## DCN 008 – Task 1 - Confirmation of Existing Control Levels

PREPARED FOR: Eric Forster, PE, PLS/City of Bend

PREPARED BY: John V. Thatcher, PLS/CH2M HILL

DATE: September 10, 2014

**BEND SE INTERCEPTOR  
KEY MAP AND SURVEY CONTROL  
SOUTH - SCHEDULES F AND G**  
DESCHUTES COUNTY, OREGON

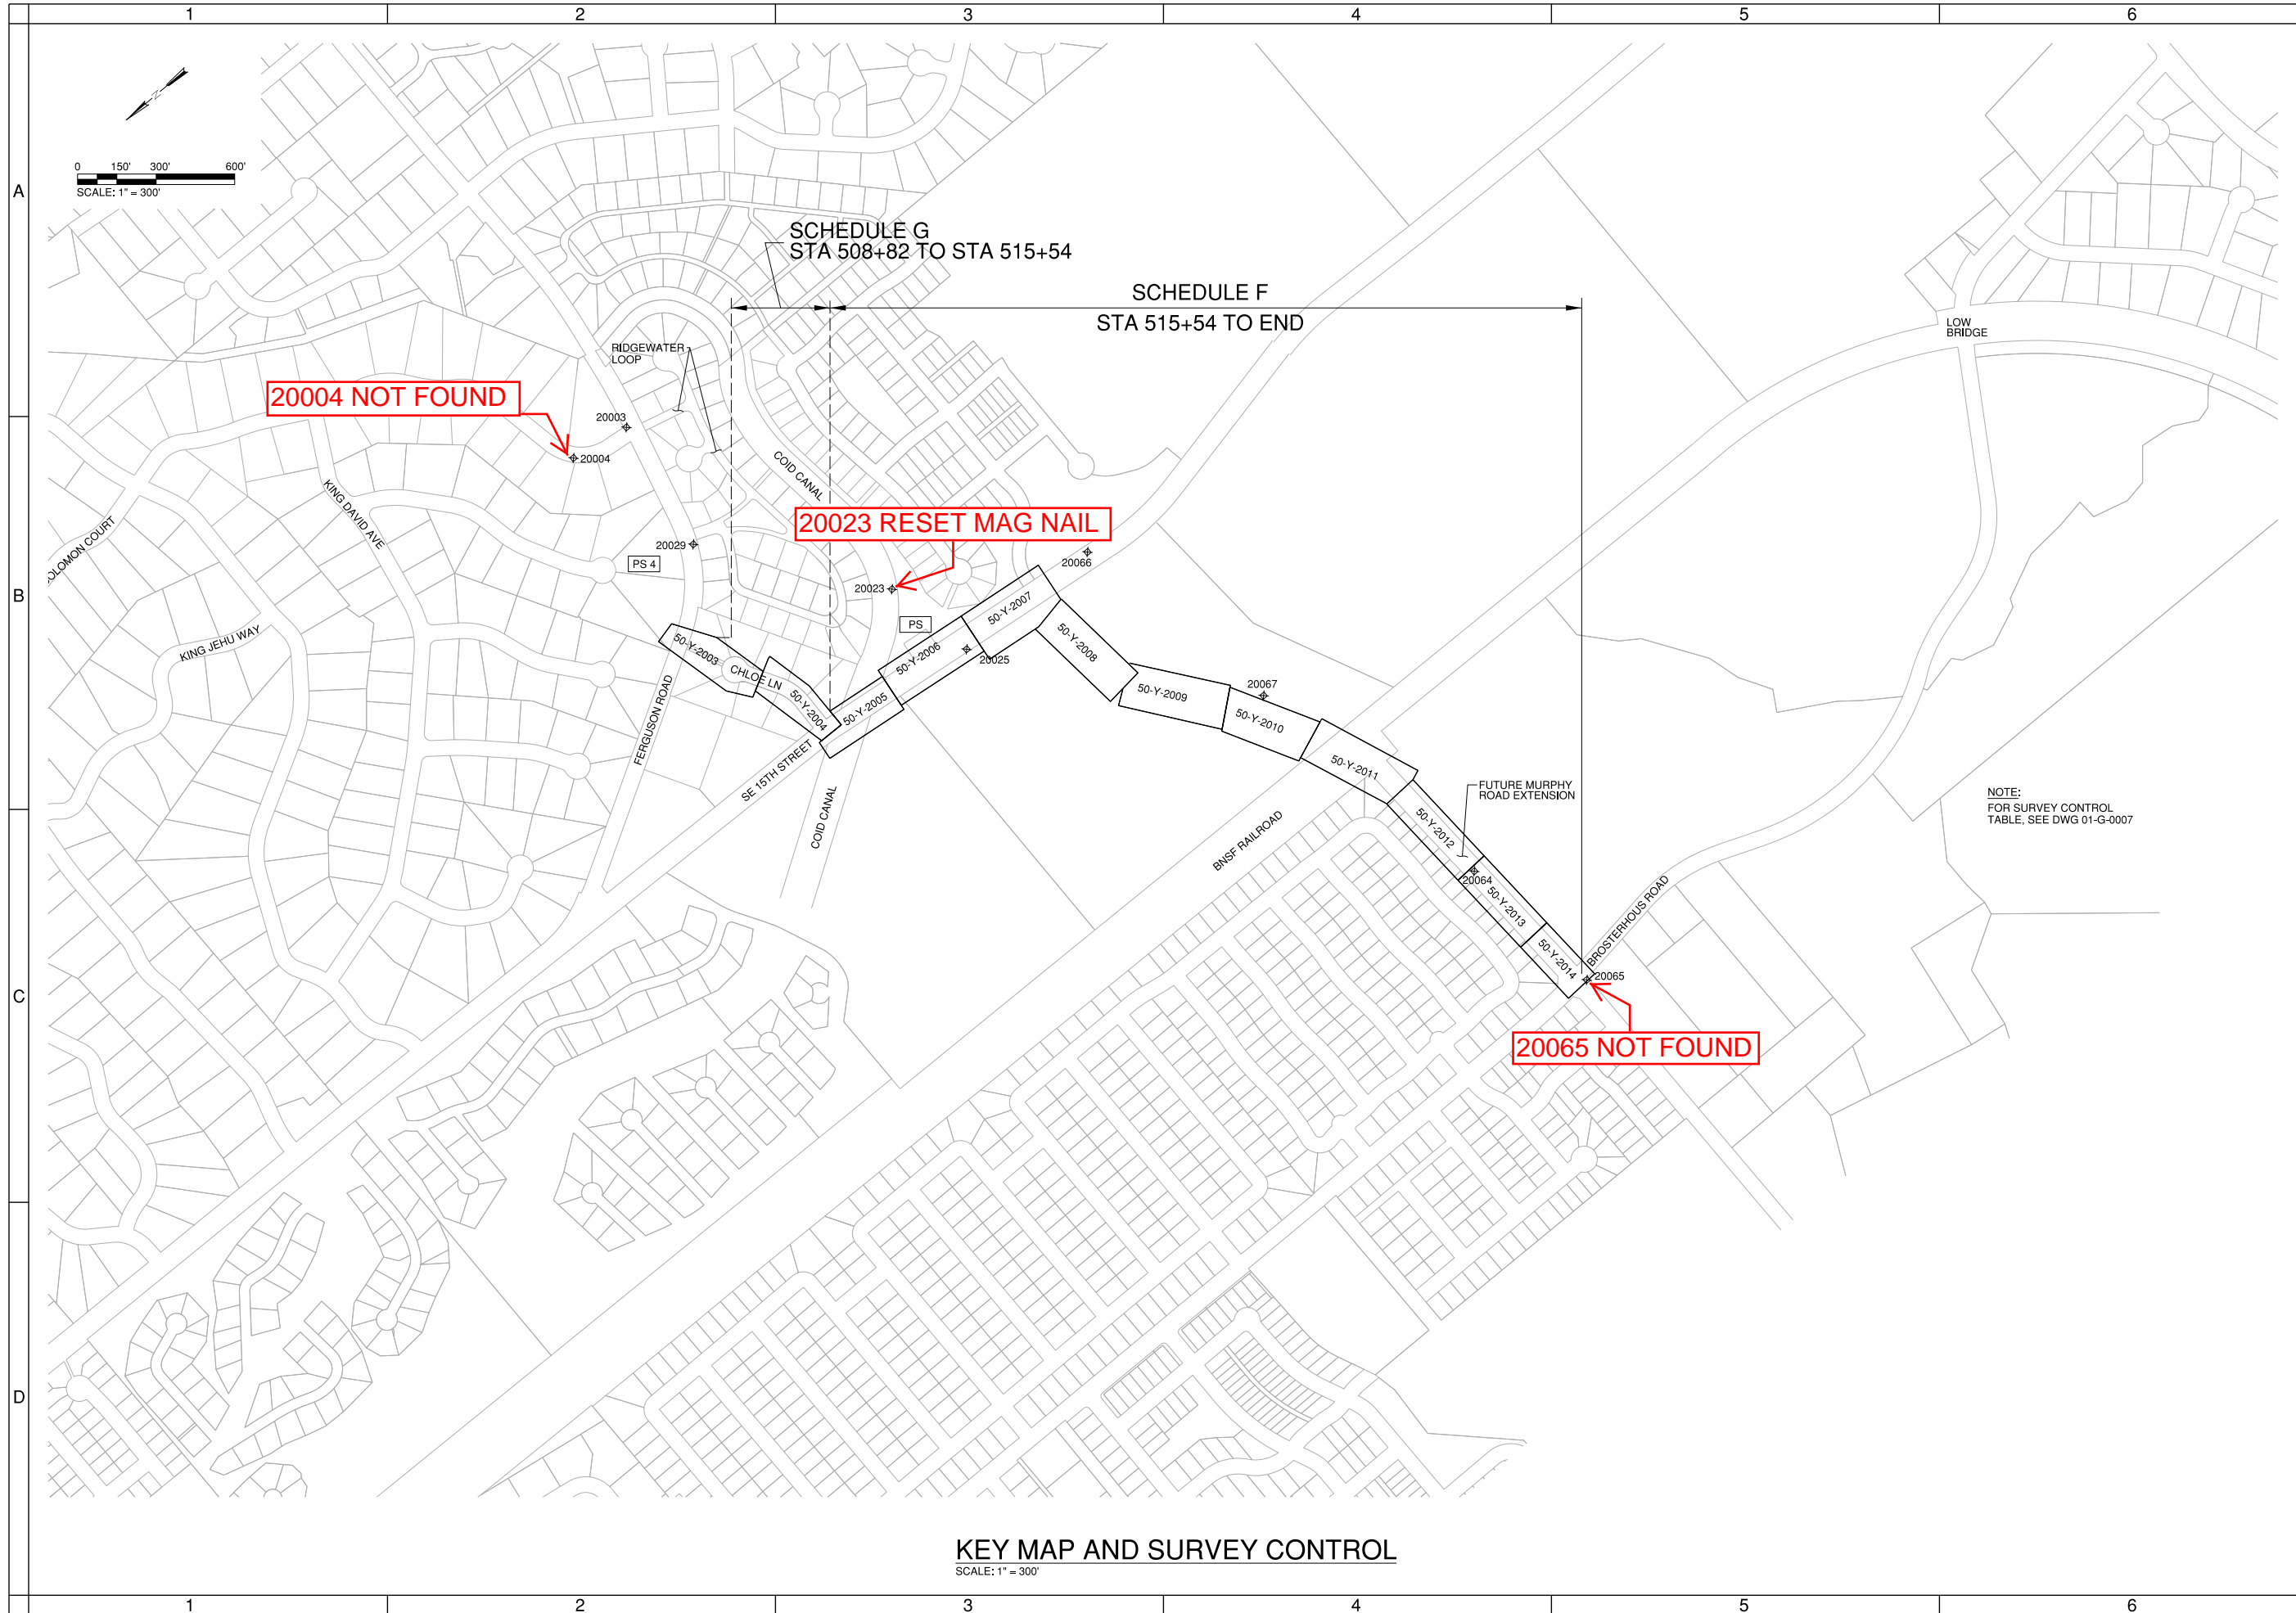
As noted in the attached Exhibit 1, two OTAK and four CH2M control points were not found, having been apparently destroyed by construction or other activity. OTAK Point 20023 was originally a magnetized (MAG) nail in the asphalt path along the south side of the COID Canal. The nail had been removed, but the hole was intact. A MAG nail was reset into the hole before measuring the elevation, and the measured elevation agrees with the record. CH2M Point 535 is described as a plastic cap on a 5/8" iron rod, and is actually a plastic cap on a 1/2" iron rod. The descriptions of all other found points are correct. All found points were marked with wooden lath painted with fluorescent pink or pink paint as appropriate.
